CONSERVATION TEAM CONSULTATION APPLICATION RESPONSE

APPLICATION REF:	25/01557/FPH & 25/01558/LBC
CASE OFFICER:	AHD
APPLICATION SITE:	Old Sextons, Sandon, Buntingford, Hertfordshire SG9 0QX
DESCRIPTION OF WORKS:	Installation of perforated drainage pipe to north and east perimeter and discharge into new soakaway, partially replace roofing, re-bed existing roof tiles, repoint chimney stack, installation of insulation boards to all external walls and re-rendering after removal of existing cementitious and loose render and replace existing fenestration. Installation of perforated drainage pipe to north and east perimeter and discharge into new soakaway, partially replace roofing, re-bed existing roof tiles, repoint chimney stack, installation of insulation boards to all external walls and re-rendering after removal of existing cementitious and loose render and replace existing fenestration. Internal works to walls and ceilings.

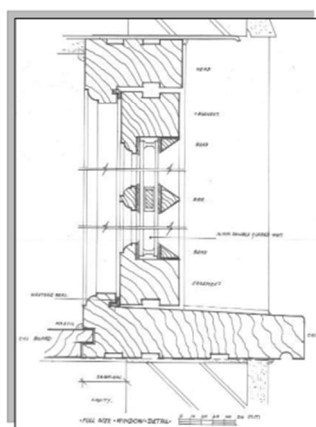
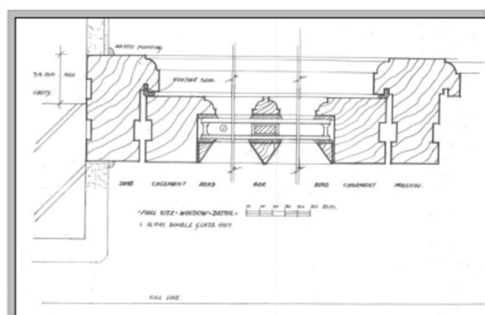
Firstly, it should be noted that window W8 on the existing and proposed rear elevations, is drawn incorrectly – should be a shorter, quarter-pane window.

Next, having considered the existing windows, windows W3, W9, W11, W13, W15 and W16 all appear to be late C19 or early C20 'Yorkshire sliders'. W15 is in particularly poor condition and probably will need replacing (this may provide an opportunity to have a new Yorkshire slider made to see how this would compare with windows W3, W9, W11, W13 and W16 being retained). Furthermore, windows W8, W14 and W18 also possess some interest and should ideally be retained.

Windows W1 and W10 are Crittal types whilst windows W4, W5, W6 are all double-glazed and windows W2 and W7 are later with top-opening vents and I encourage these to be replaced with 6-pane, side-hung casements or fixed lights. I am satisfied that windows W12 & W17 can be replaced with slimlite windows.

5. Notwithstanding the submitted drawings, windows W3, W8, W9, W11, W13, W14, W16 and W18 shall be retained unless otherwise agreed and approved in writing by the Local Planning Authority.

Amend drawings to address window W8 otherwise subject to the above conditions, scheme is acceptable.
